Received
WILLIAMSON COUNTY, TEXAS
CHANGE ORDER NUMBER: 1

Project: 1604-075
Roadway: CR 110 South
CSJ
Number: _____

**County Road 110 South
Williamson County Project No. 1604-075**

Change Order No. 1

Culvert Performance Curve Plot: STR 6

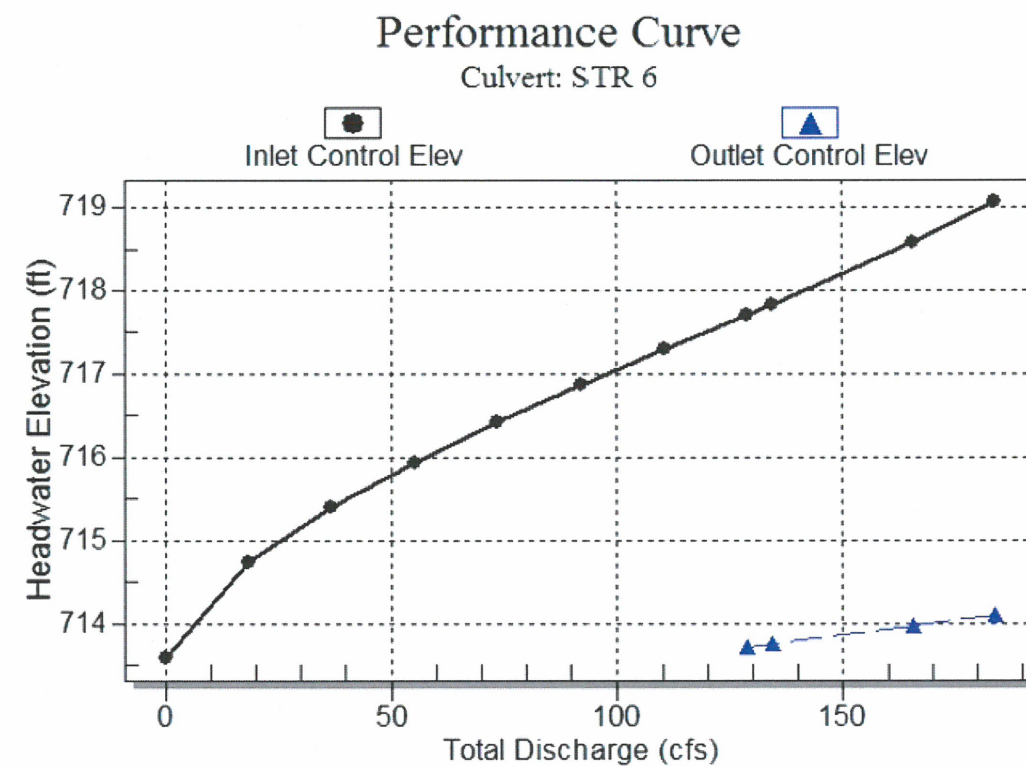
This Change Order modifies the outfall location of Box Culvert 6 to match existing conditions, per the request of the downstream property owner. This redesign resulted in a decrease of the total box culvert length and quantity changes for various other drainage structure items.
